## Addendum-01

**NW827 - ANDERSON LIBRARY CONFERENCE CENTER - East Dock Renovation - IU# 20240675**  
**Indiana University Northwest**  
**Gary, Indiana**

Addendum Number One

SHEET NO.  
**A3.0**  
JOB NUMBER  
IUN2402

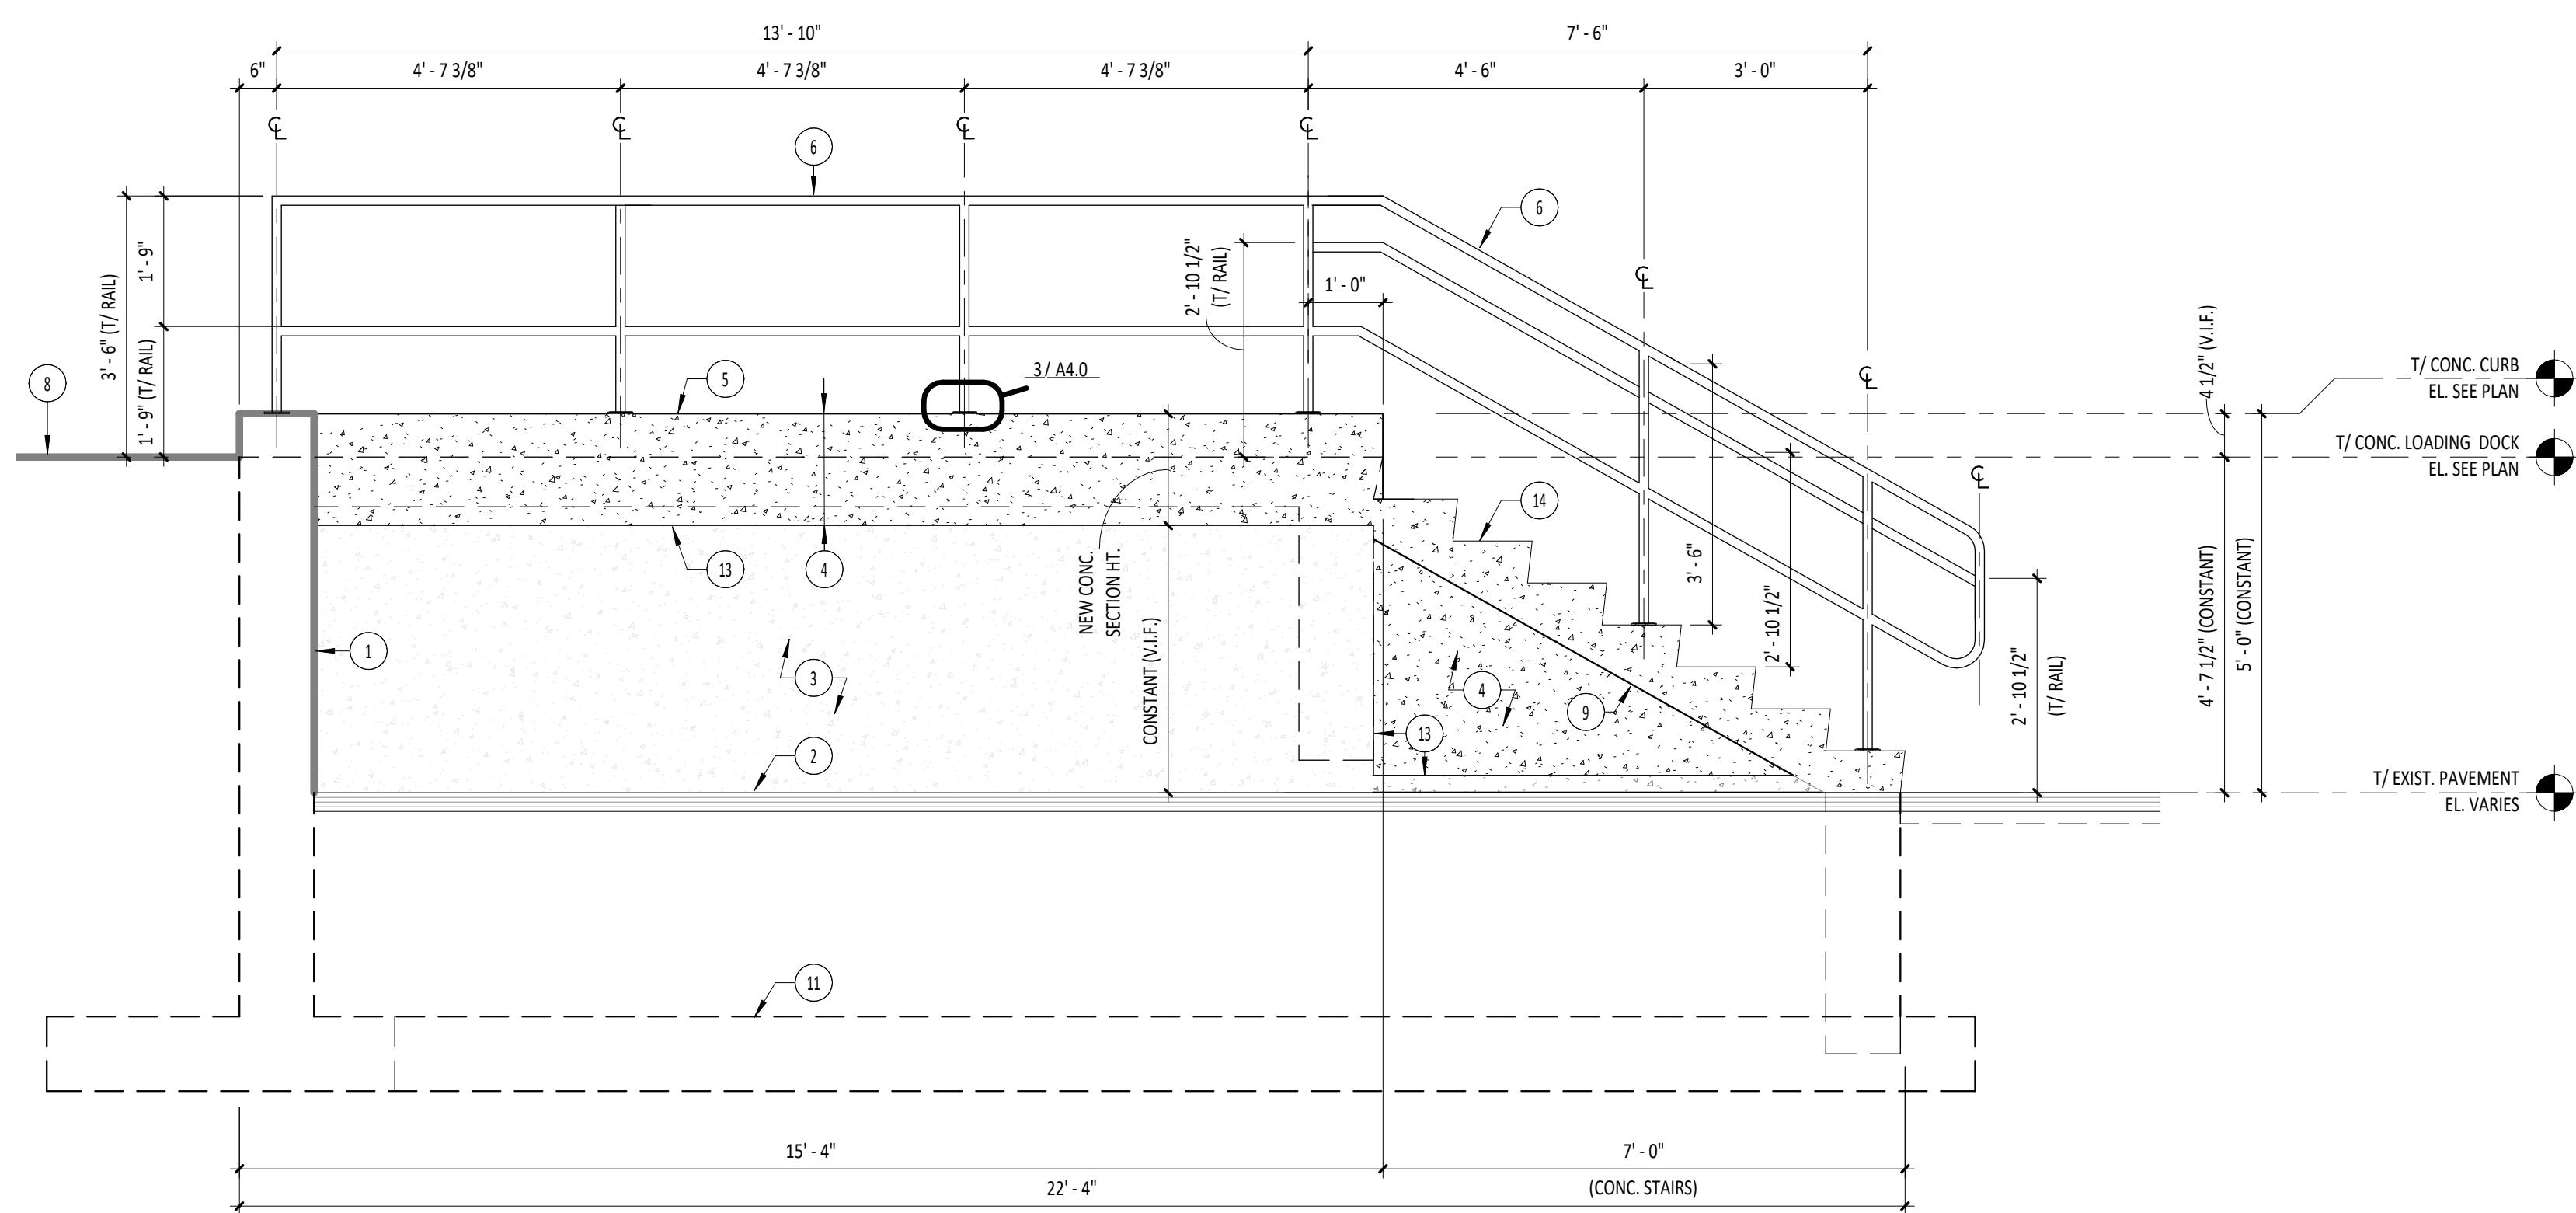
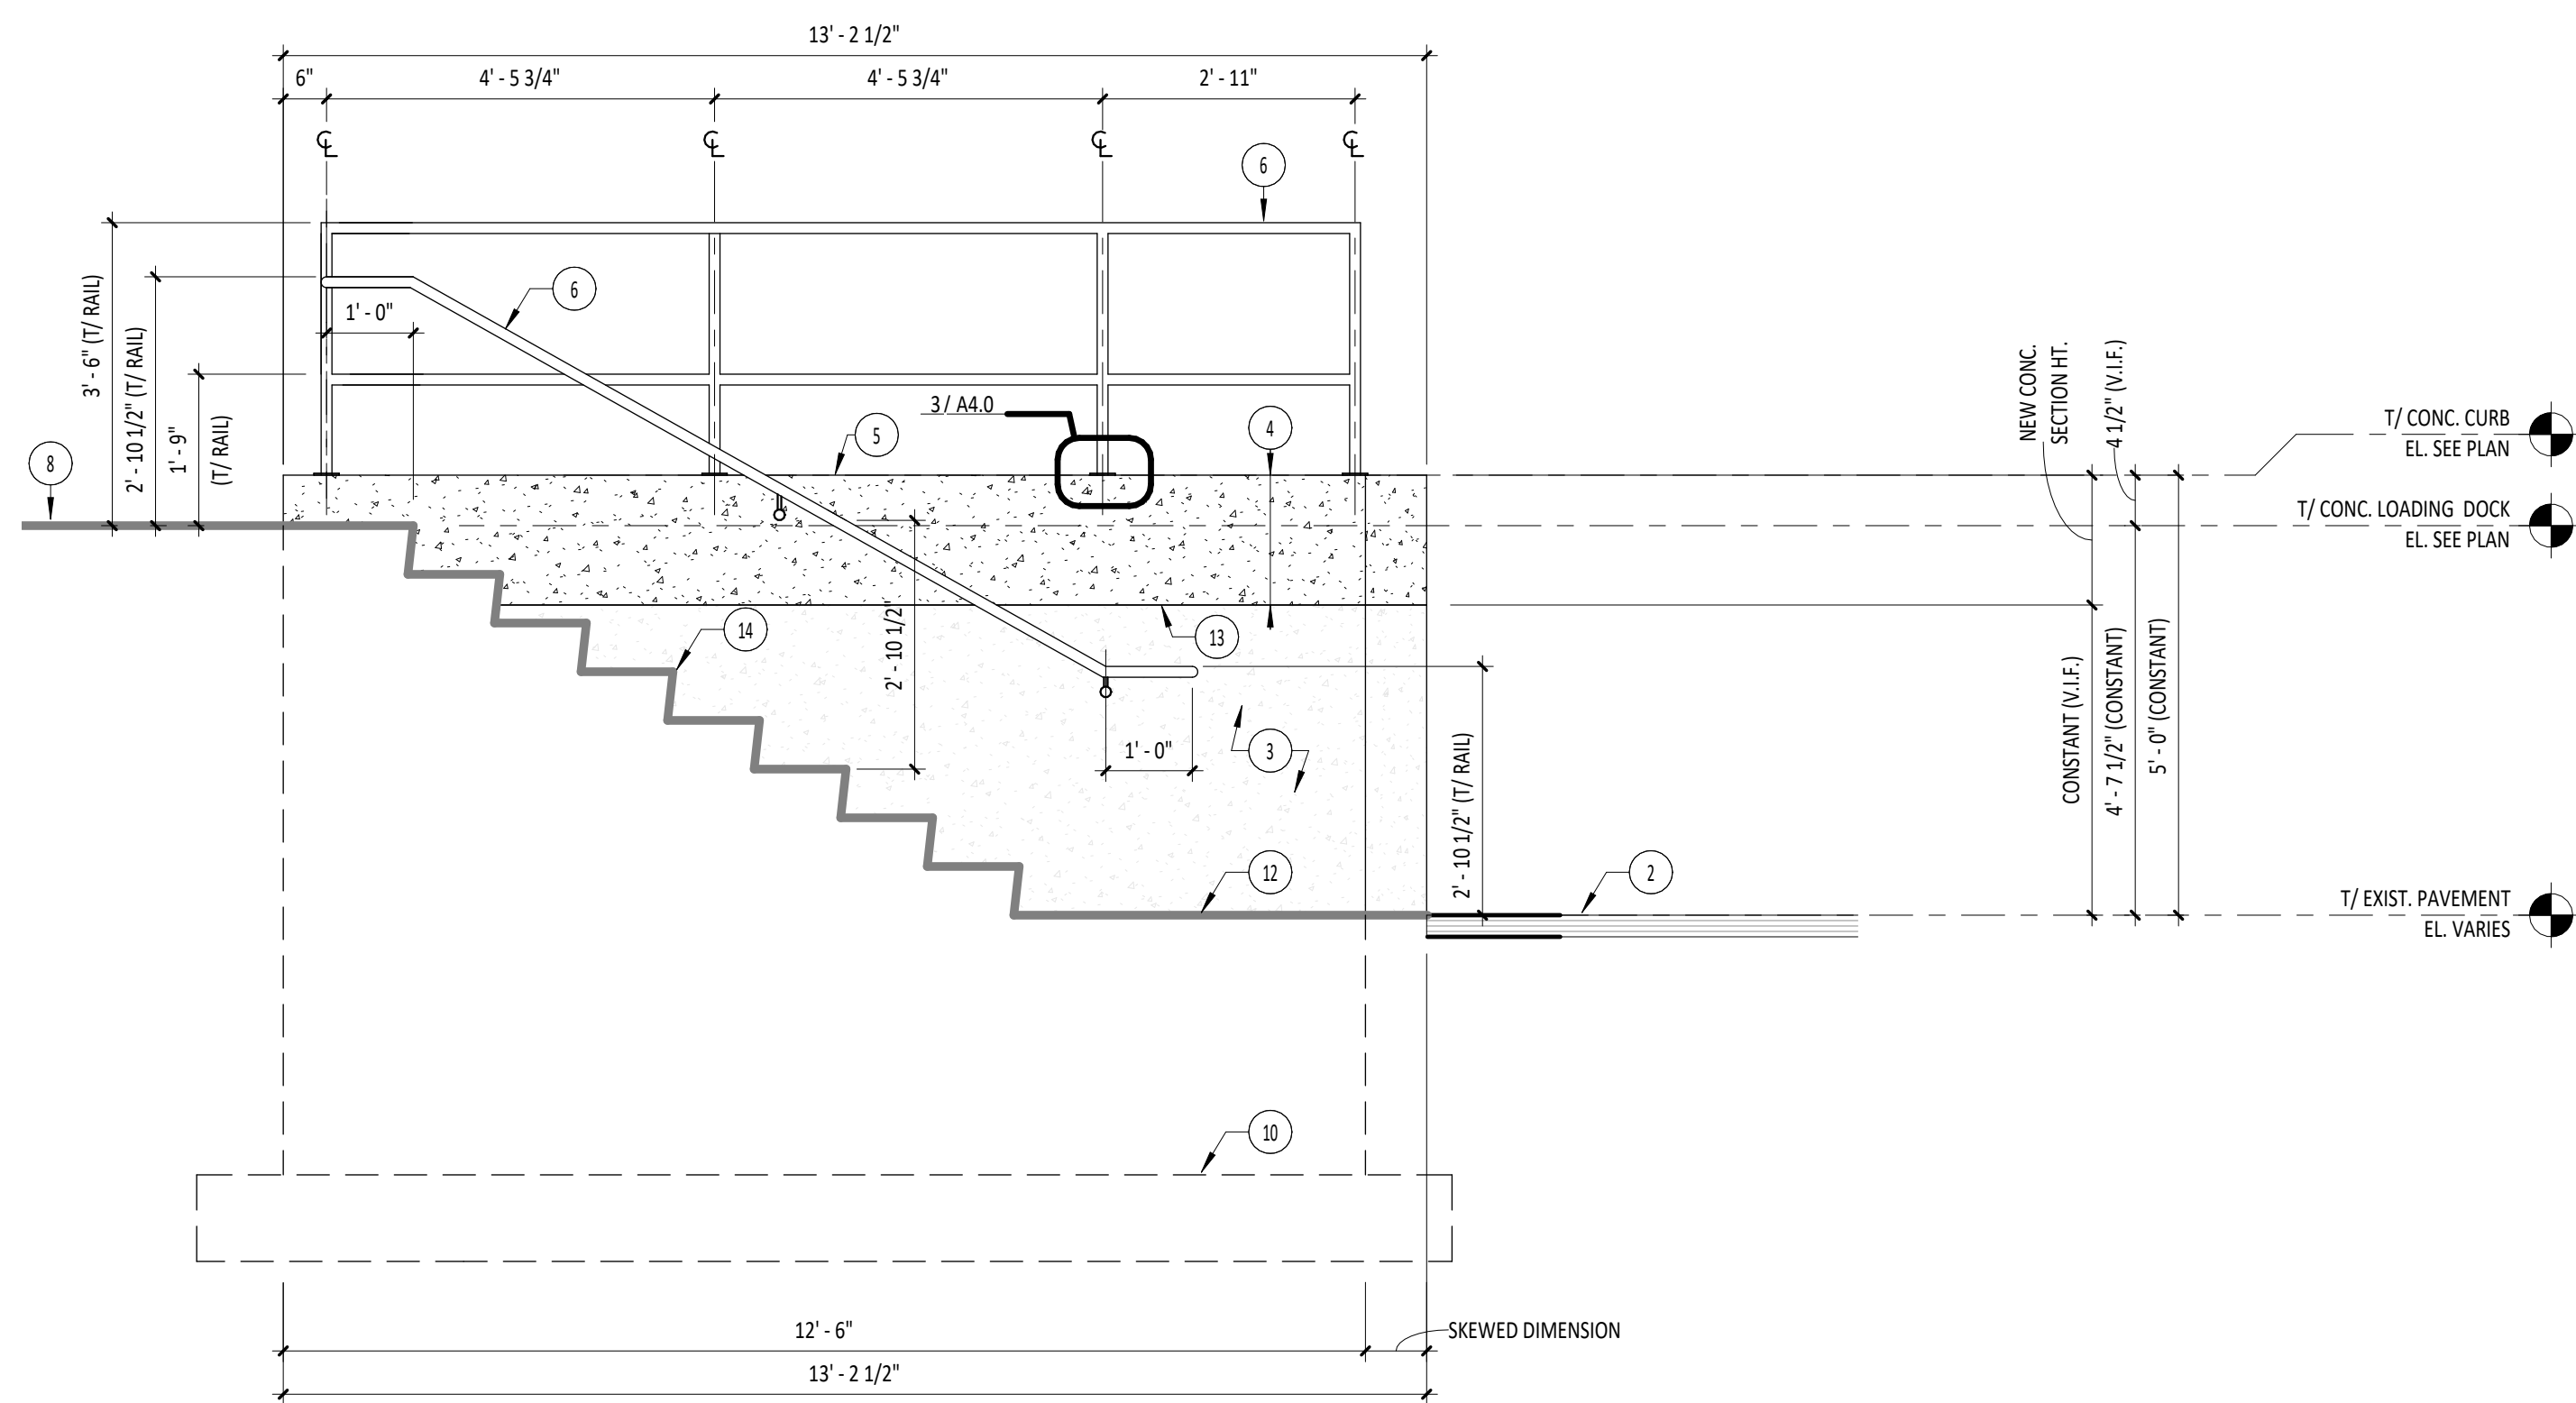
**1.02 Reference:** Revised sheet A3.0 - LOADING DOCK ELEVATIONS with revised date 25 April 2025.

**A. Clarification:** Elevation Notes No. 6 was revised to clarify stainless steel guardrails finish type.

- 5 CONCRETE CURB CAST INTEGRALLY WITH REINFORCED CONCRETE WALL SECTION. REFER TO WALL SECTIONS AND STRUCTURAL DRAWINGS.
- 6 1 1/2\"/>
- 7 PROVIDE STAINLESS STEEL LOOP WELDED TO GUARDRAIL POST FOR SUPPORT OF CHAIN LINK. COORDINATE SIZE AND HEIGHT WITH OWNER AND ARCHITECT.
